Project Reference: Delh.2018.049-6_B

ANGLO AMERICAN

17 APRIL 2019

**DER BROCHEN PROJECT GROUNDWATER
MONITORING PROGRAMME REVIEW AND PROPOSED AMENDMENT**

Figure 2. Location of Richmond production and monitoring boreholes.

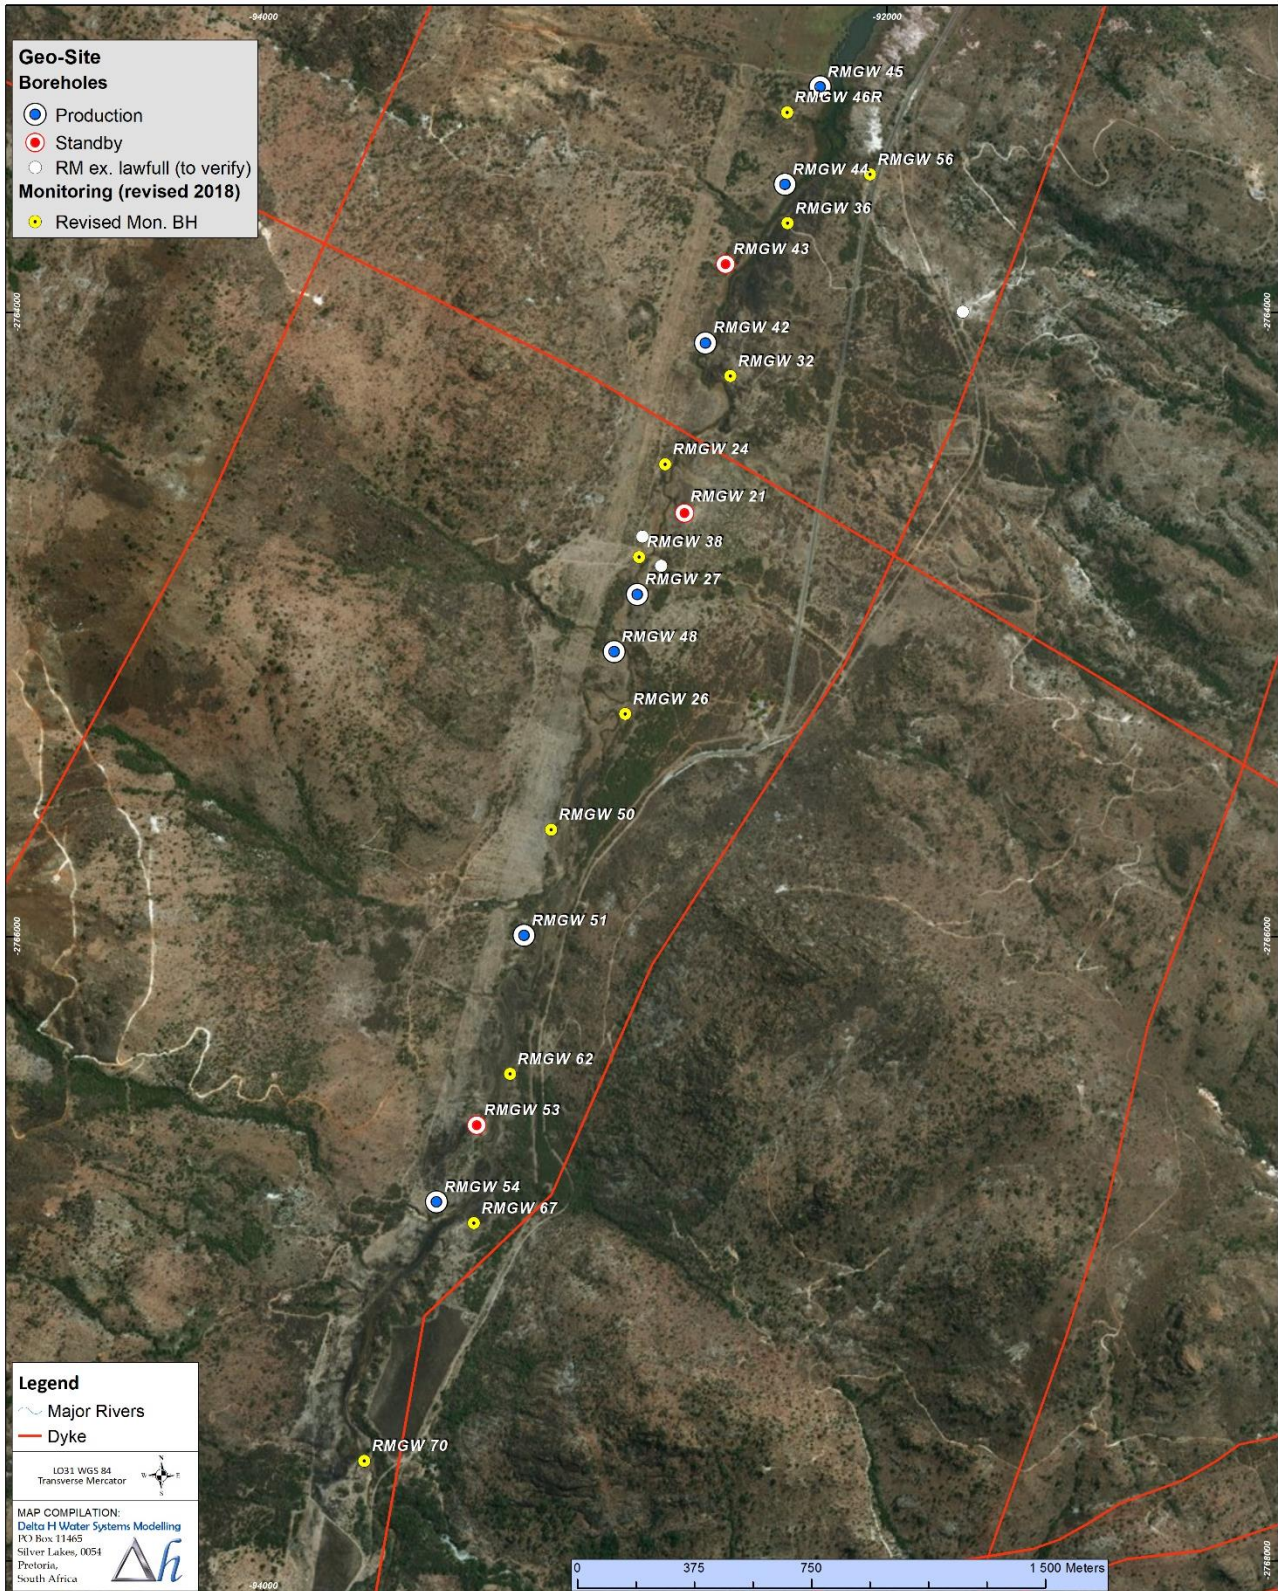
The revised borehole list and monitoring tasks (together with reasonings for discontinuation) are given in Table 3-1, while the proposed monitoring borehole locations in relation to the recently revised Richmond wellfield production boreholes are shown in Figure 2. Numerous Richmond wellfield boreholes are within metres of each other and show similar water level trends (GCS, 2018). Based on the distribution of proposed production boreholes and existing potential wellfield monitoring boreholes, the list has therefore been reduced from 44 to 25 boreholes. The revised monitoring boreholes together with the reasoning are listed in Table 3-1.

Figure 3. Location of Helena/Der Brochen wellfield and monitoring boreholes.

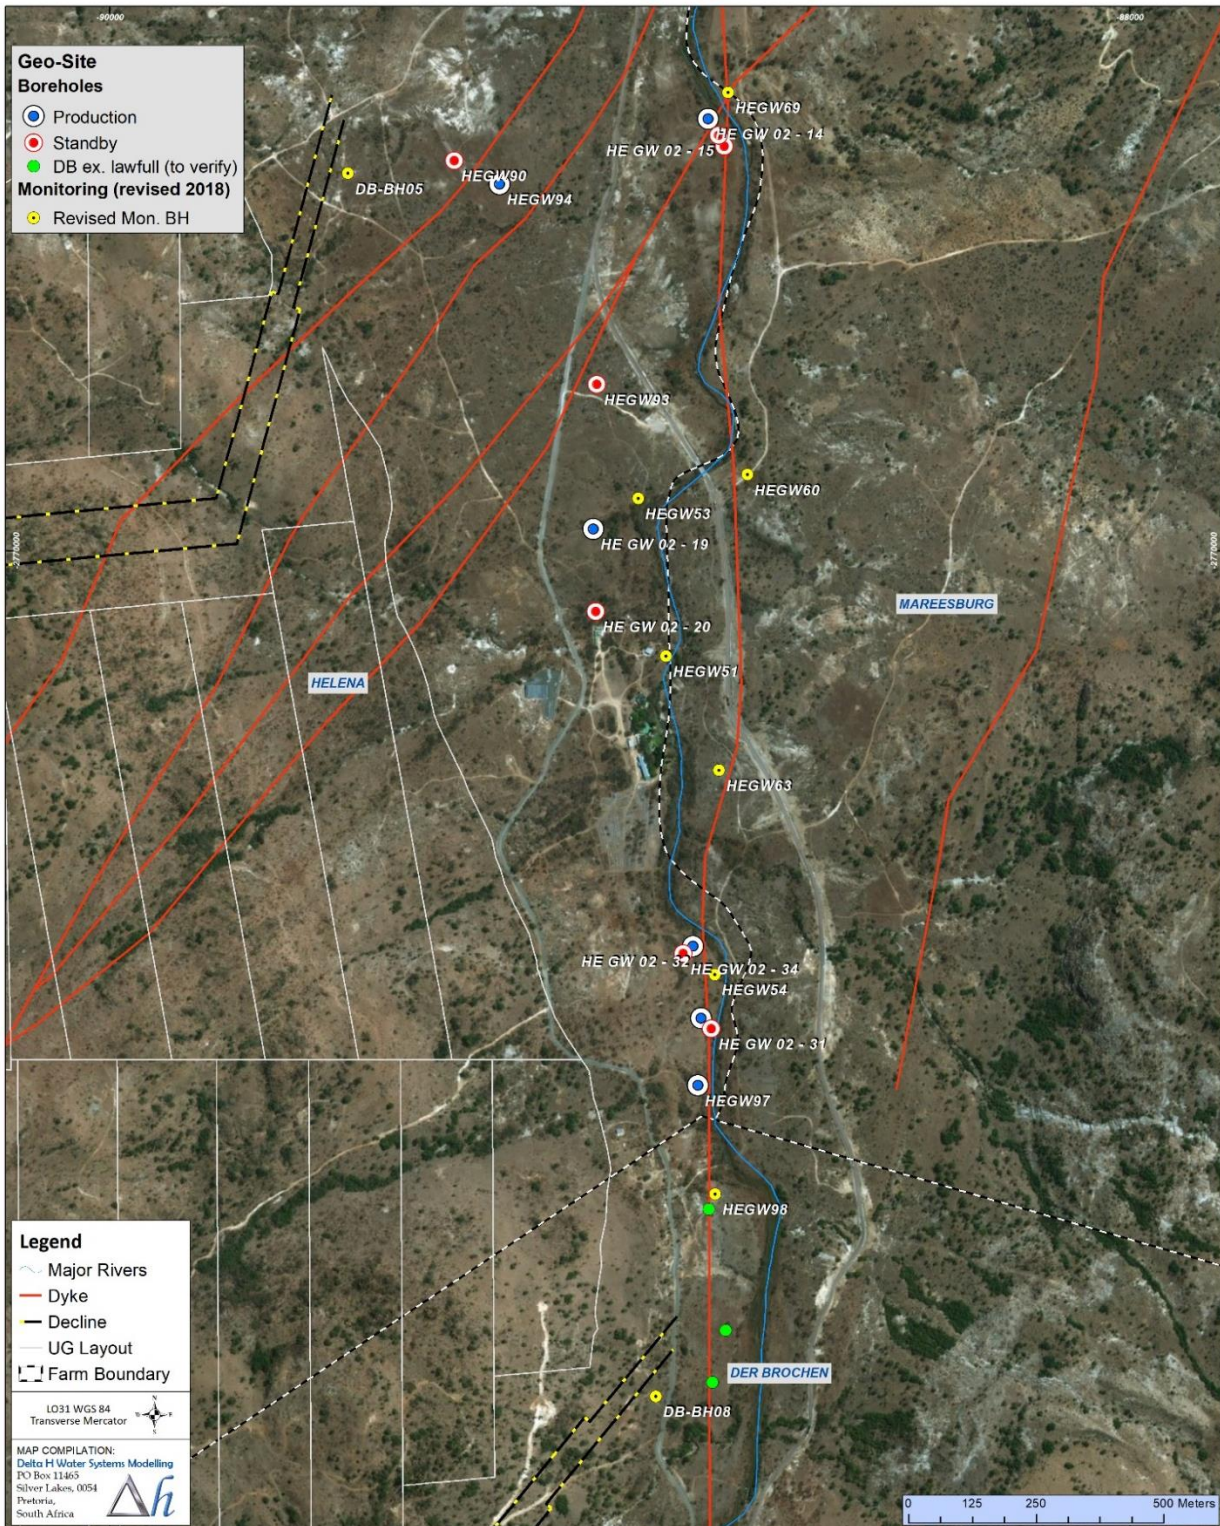
The recently revised production boreholes for the Helena wellfield are shown in Figure 3. The proposed Der Brochen Project underground workings will be developed west of the wellfield area. Two existing boreholes (names) should therefore be added to monitor the potential impact from the proposed mining activities and associated dewatering on the wellfield (Table 3-2), while 3 boreholes can be discontinued due to their proximity to other monitoring boreholes. A detailed wellfield management plan will be included in the final Der Brochen Project (PFS-B) Report.

Figure 4. Location of the Helena TSF monitoring boreholes.

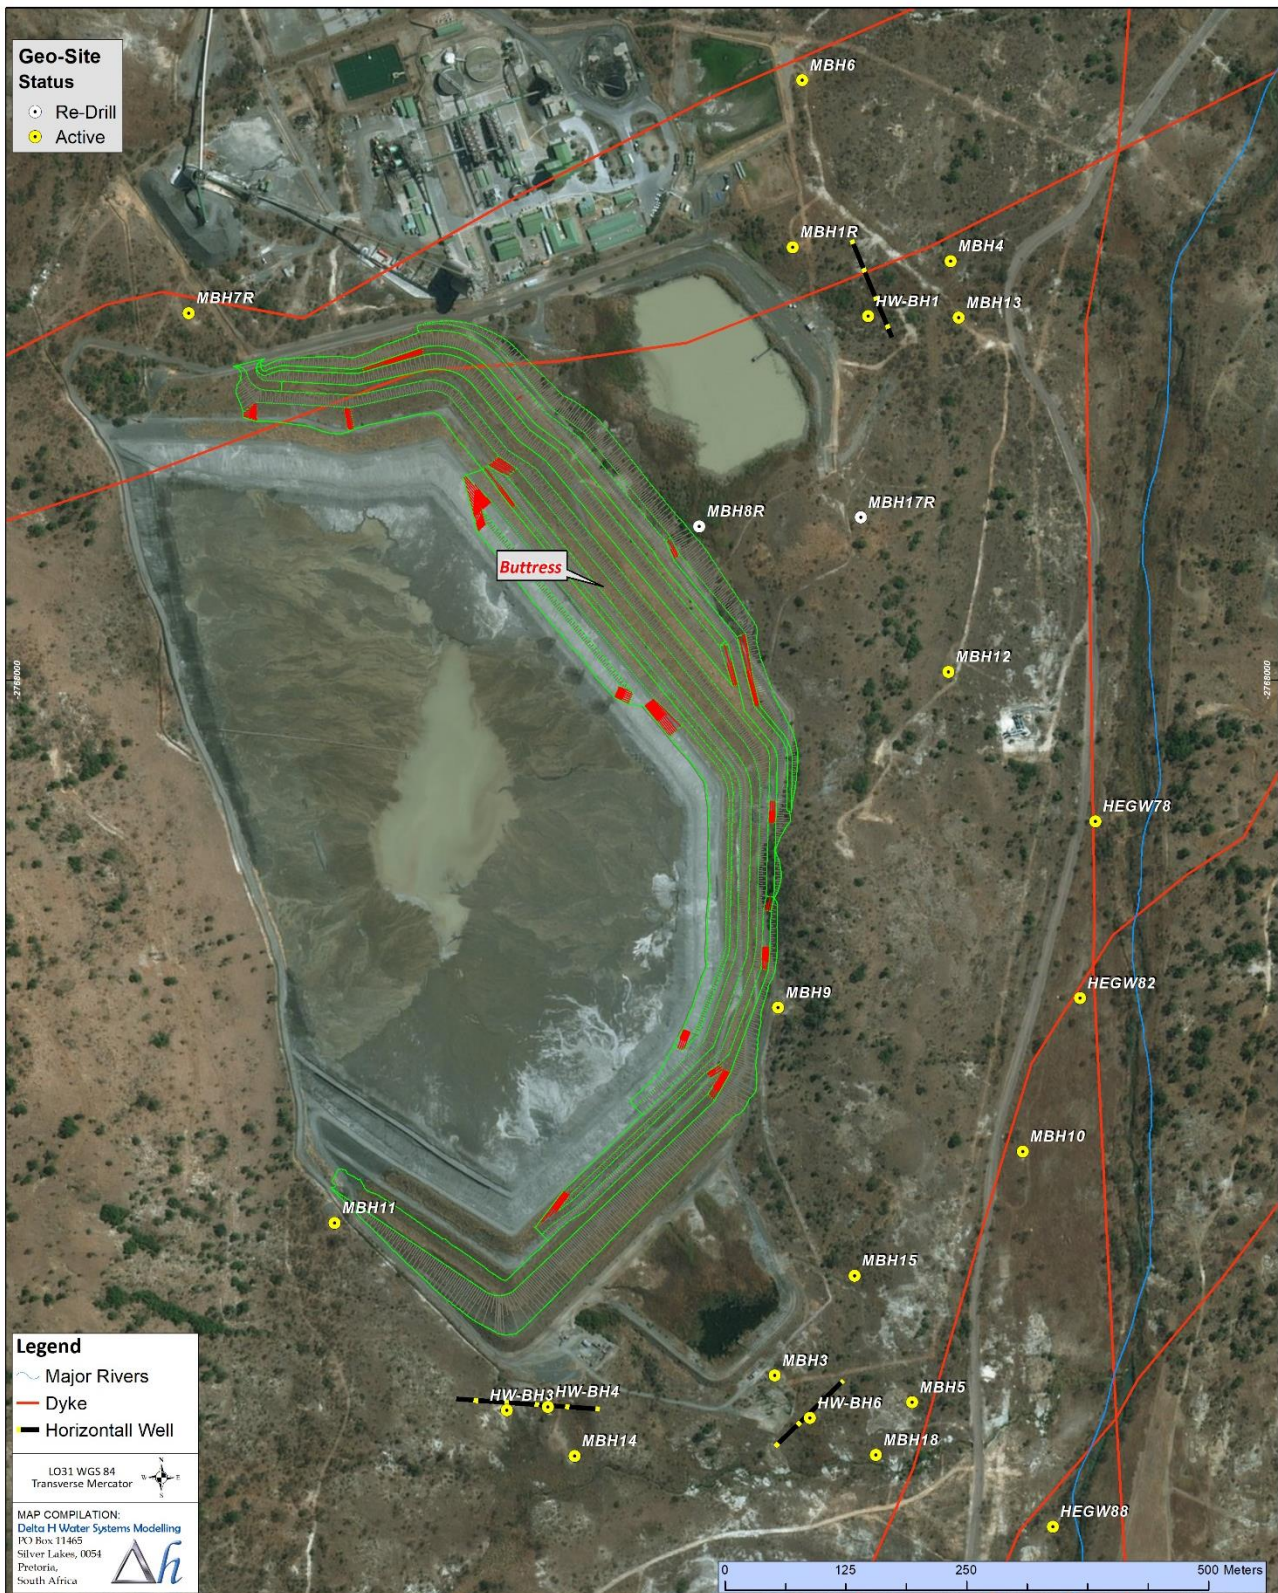
The distribution of active (and proposed) monitoring boreholes is shown in Figure 4. Recently a number of additional boreholes were drilled as part of the hydraulic containment system (scavenger wells HW-BH1, HW-BH2, HW-BH3, HW-BH4 and HW-BH6), while MBH12, MBH13, MBH14, MBH15, MBH16, MBH17 and MBH18 were drilled to ensure complete spatial coverage of the monitoring programme. As a result, there are two components of monitoring required at the Helena TSF: firstly, to monitor the migration of the contamination plume, and secondly, to determine the effectiveness of the hydraulic containment system. Based on the understanding of the plume development, the revised monitoring boreholes for the Helena TSF are listed in Table 3-3. Quarterly monitoring of groundwater quality and levels is proposed.

Figure 5. Location of the Maresburg TSF and proposed DMS Stockpile monitoring boreholes.

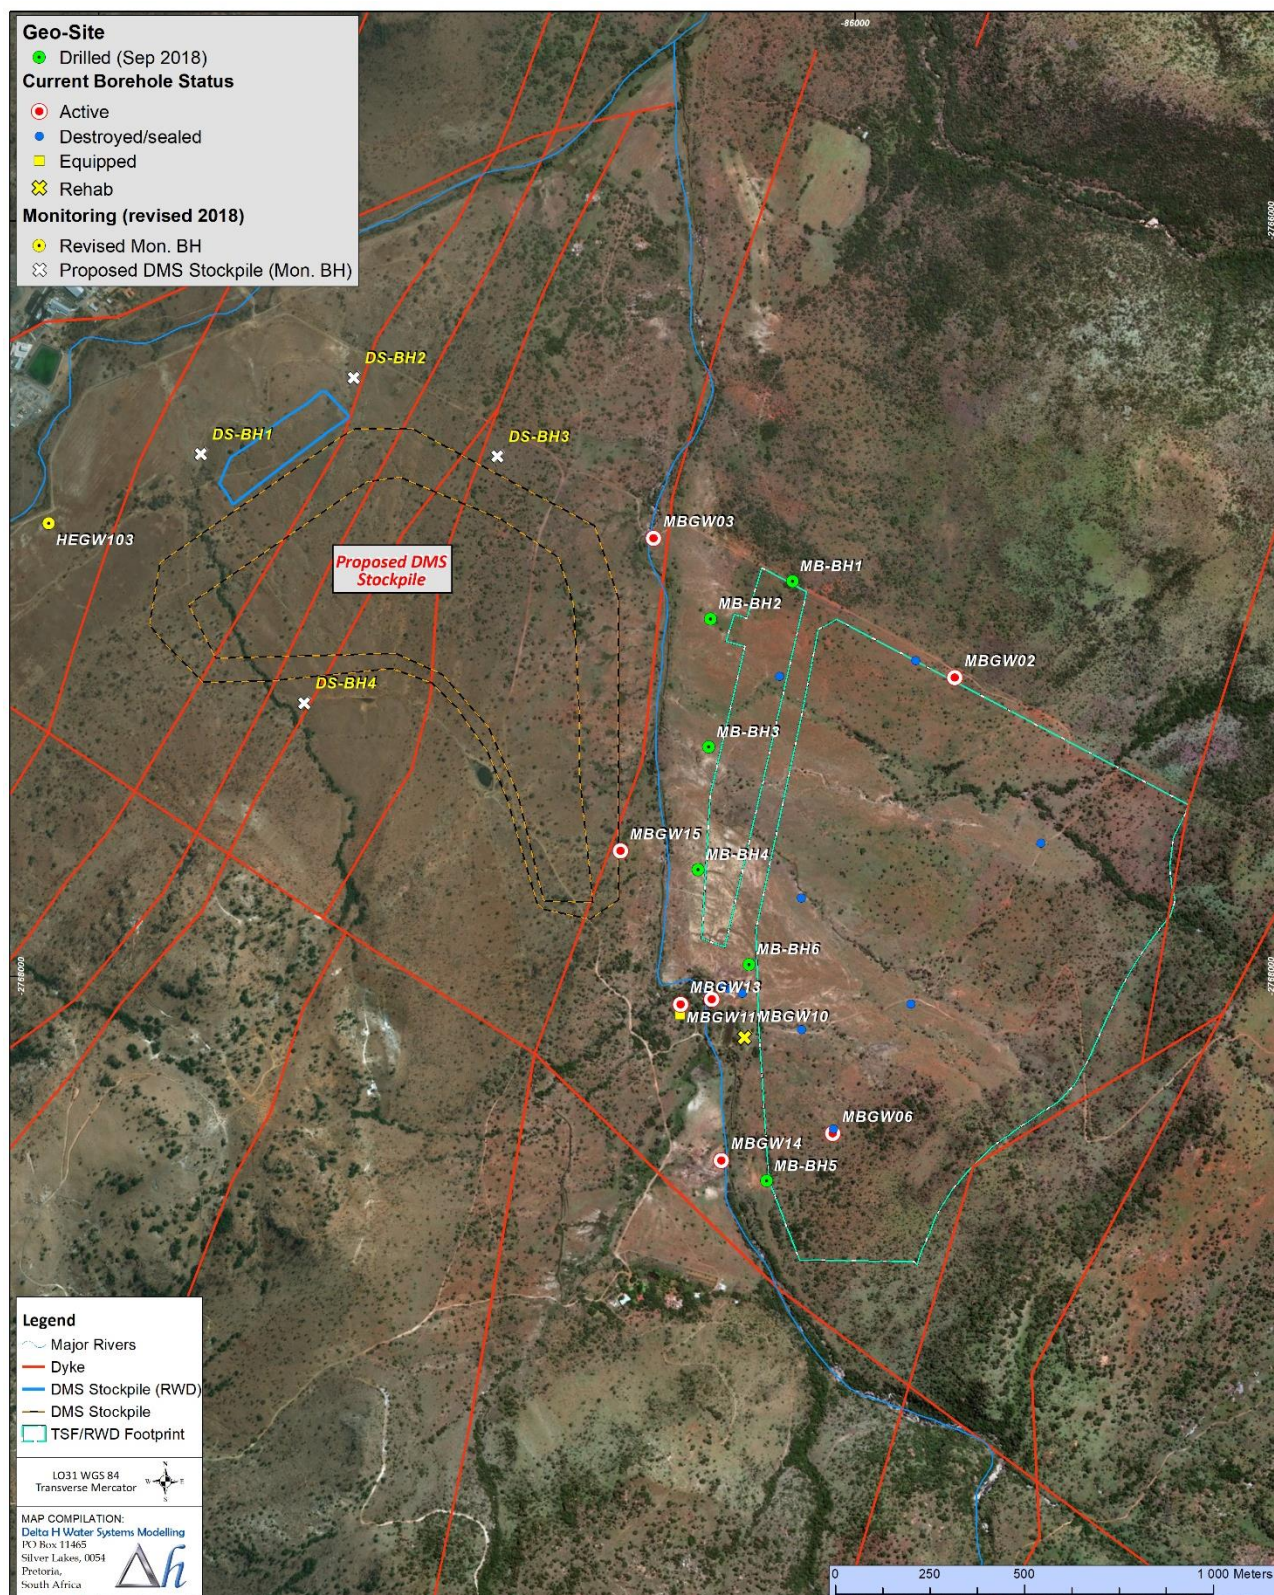
Based on the outcome of the site-specific numerical groundwater flow and transport model developed for the Mareesburg TSF (Delta-H, 2015), a tiered (phased) approach was put forward as mitigation controls for the potential seepage plume migration. The potential implementation of a Tier 2 interception system (i.e. scavenger wells) should be determined by the future groundwater monitoring data. Existing boreholes within the footprint of the TSF were sealed prior to construction. Other existing monitoring boreholes (i.e. MBGW03, MBGW13, MBGW14, MBGW, 15) are beyond the Mareesburg tributary and can be regarded as baseline receptor monitoring. Additional monitoring boreholes for the Mareesburg TSF were drilled in September 2018. The current status and revised monitoring schedules are listed in Table 3-4 and shown spatially in Figure 5. The figure also shows the preliminary monitoring borehole locations for the Dense Media Separation (DMS) Stockpile.
